Manual 15, Cost Development Guidelines

Market Implementation Committee
April 8, 2026

Revision 49 (10/01/2026):

All changes are conforming to Regulation Redesign Phase II

Cost Increase due to Heat Rate increase during non-steady state

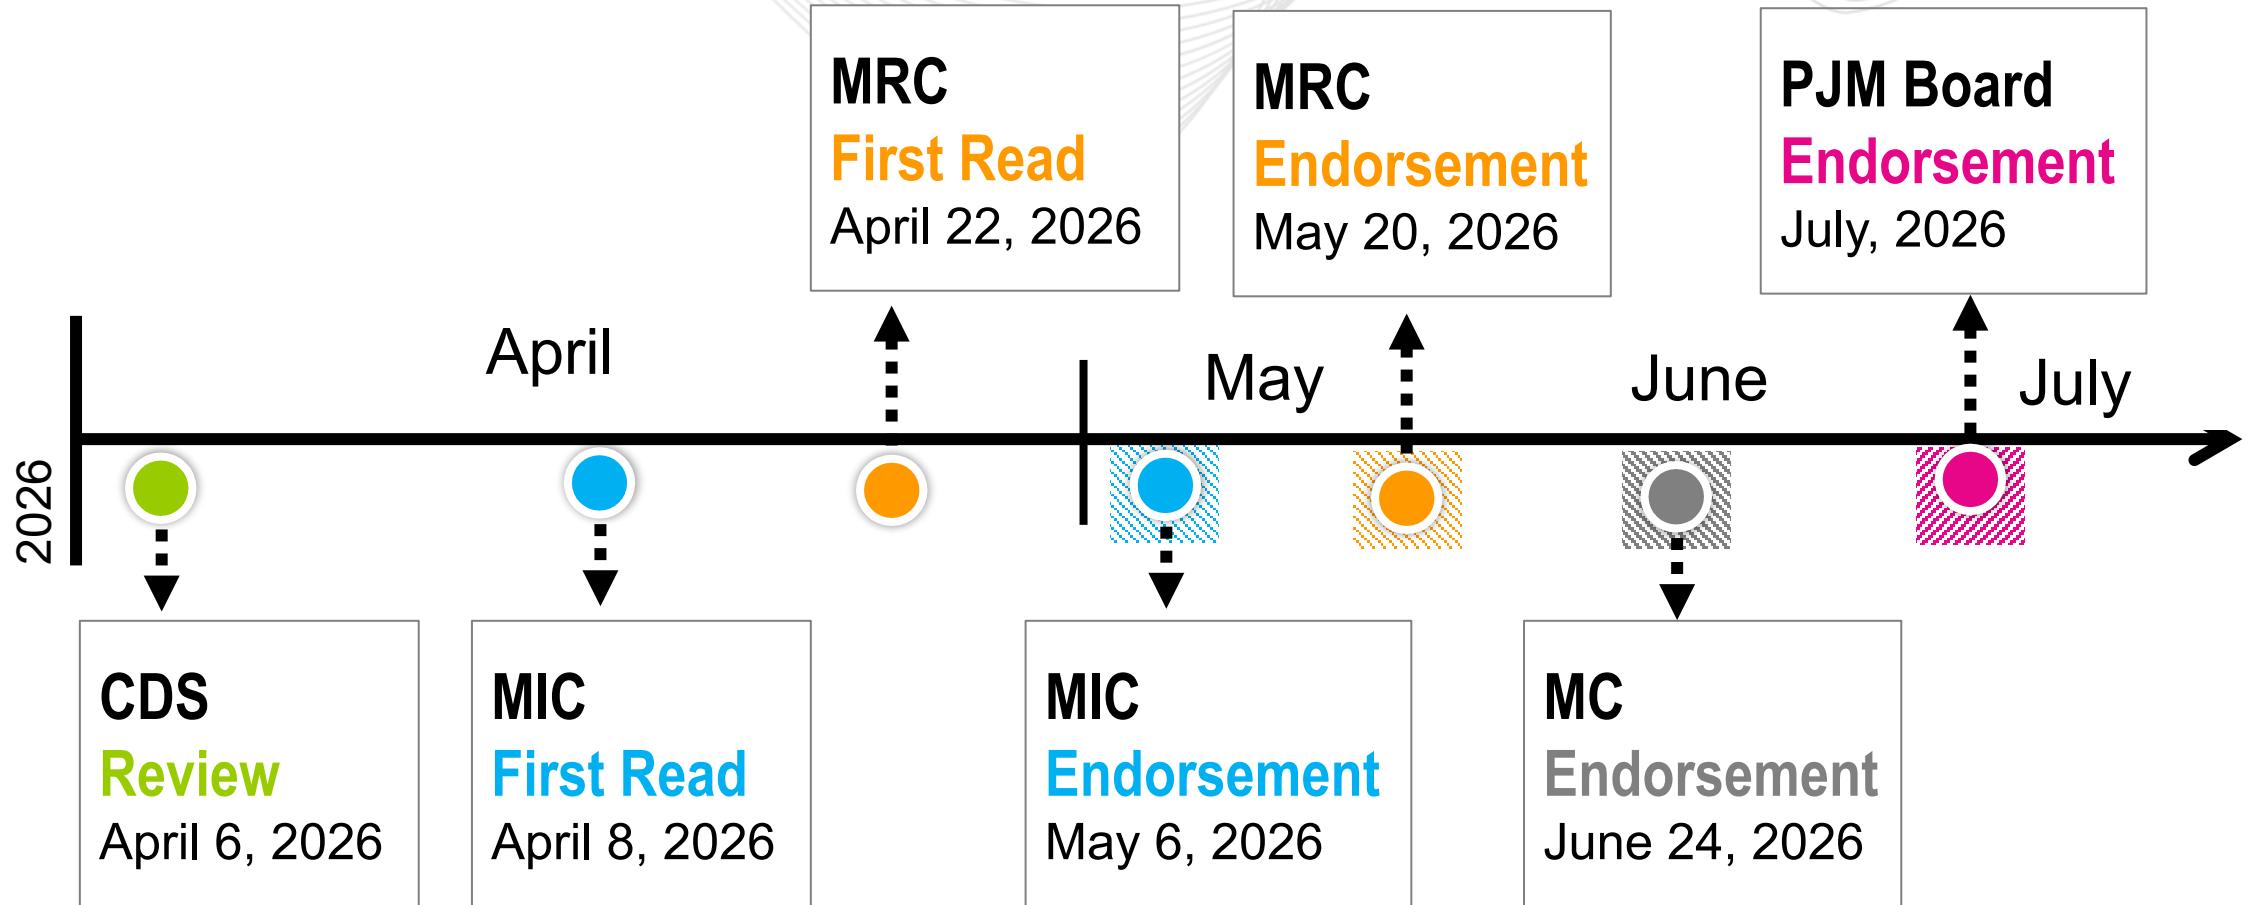
- Updated heat rate loss factor from .35% to .175%

The cost (in \$/MWh of Regulation) increase due to the heat rate increase resulting from operating the unit at a non-steady-state condition. This heat rate loss factor rate shall not exceed 0.17535% of the top Regulation load MW heat rate value.

Heat Rate Adjustment (Non-Steady State Operation)	Value	Units
Total Operating Point Heat Rate	9,000.0	Btu/kWh
Heat Rate Loss Factor (Max per M15)	0.17535%	
Heat Rate Loss	3.15	MMBtu/Hr

$$(EconomicMaximumHeatRate * 0.175\%) * 1MMBtu / 1,000,000Btu * 1,000kW / MW * EconomicMaximumMW$$

$$(9,000Btu / kWh * 0.175\%) * 1MMBtu / 1,000,000Btu * 1,000kW / MW * 100MW = 3.15 MMBtu / Hr$$
